# Comparing the PCI2050B to the PCI2050

*PCI Bus Solutions*

This document discusses the differences between the PCI2050 and the PCI2050B. In general, the PCI2050 and the PCI2050B are very similar. They both support up to 9 masters on the secondary interface and they both support up to 3 delayed transactions. The main difference between the PCI2050 and the PCI2050B is that the PCI2050B supports 66MHz. Also, all errata of the PCI2050 are fixed in the PCI2050B.

**Figure 1. Clock Divider**

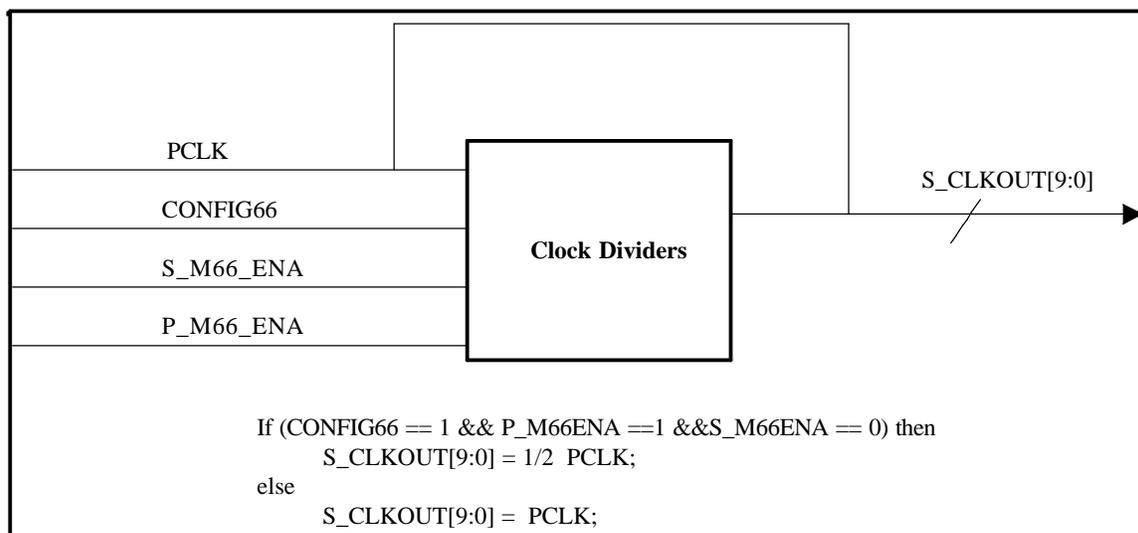
The PCI2050B does not support 33 MHz primary/66 MHz secondary bus operation. If CONFIG66 is high and P\_M66ENA is low, the PCI2050B pulls down S\_M66ENA to indicate that secondary bus is running at 33 MHz. The 2050B generates the clock signals S\_CLKOUT[9:0] for the secondary bus devices and its own interface. It divides the P\_CLK by two to generate the secondary clock outputs whenever the primary bus is running at 66 MHz and secondary bus is running at 33 MHz as shown below.
